# A47 North Tuddenham to Easton Dualling

**Scheme Number: TR010038**

## **9.20 Applicant's Written Summary of Oral Submissions at ISH2**

<b>Regulation Number:</b>	Rule 8(1)(c)
<b>Planning Inspectorate Scheme Reference</b>	TR010038
<b>Application Document Reference</b>	TR010038/EXAM/9.20
<b>Author:</b>	A47 North Tuddenham to Easton Project Team, Highways England

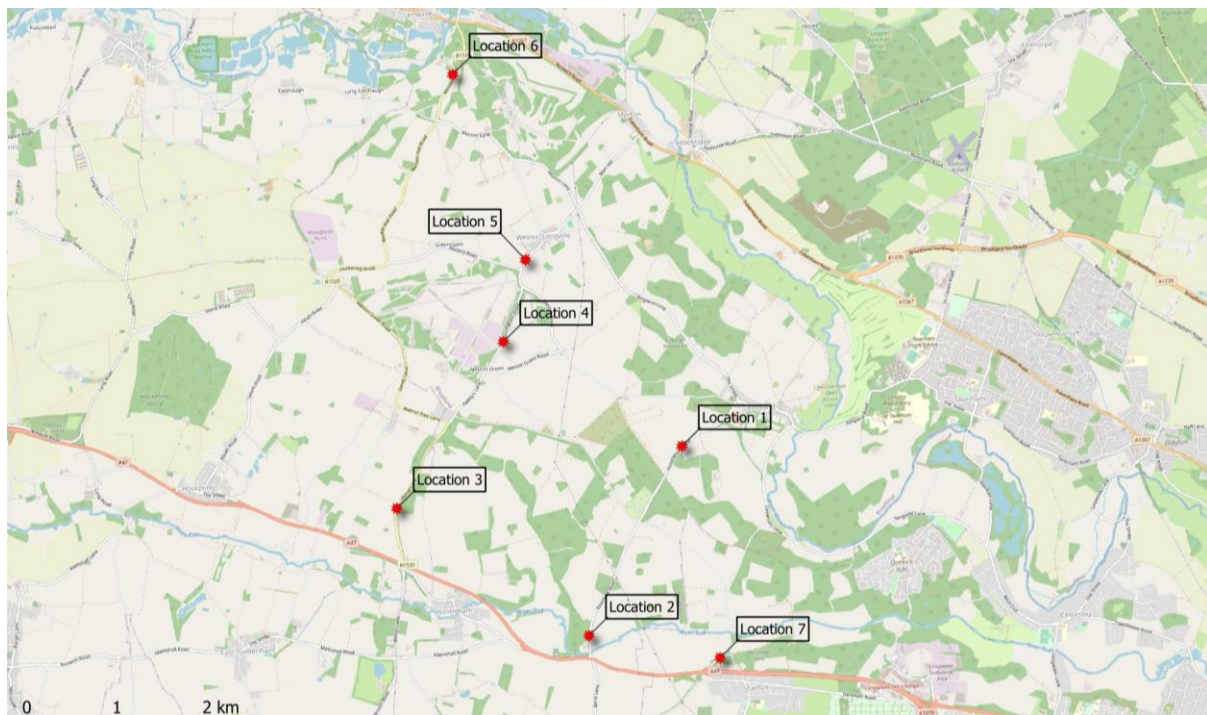
7	<p>The Examiner asked what are the predicted traffic levels in Western Longville.</p>	<p>The Applicant to provide this information in writing. The Applicant looked at significant modelling.</p>	<p>The Applicant has included a table, in Annex A to this document, which summarises the various scenarios ran including the implementation of the TTRO on Honingham Lane.</p>
8	<p>The Examiner asked the Applicant to update the Examiner on the proposed transfer of</p>	<p>The Applicant is continuing to engage with NCC for handover of the parts of the A47 that will be de-trunked. The parties hold a regular de-trunking call.</p> <p>Asset inventory data has been requested from the Applicant and is</p>	<p>The Applicant has no further submissions to make.</p>

Various scenarios were modelled in the strategic highway traffic model and are presented below together with the column heading definitions and a location plan.

Overall, the model analysis indicates that the scenarios which include the Church Lane (Easton) closure, show there is no increase in traffic through Weston Longville. However, the analysis does demonstrate an increase in traffic at Locations 3 and 4 in the DS1 and DS2 scenarios compared to the “DN” scenario. This is to be expected given the traffic dispersal on the higher quality routes (Location 1 to 3 & Location 6 to 4 to 3).
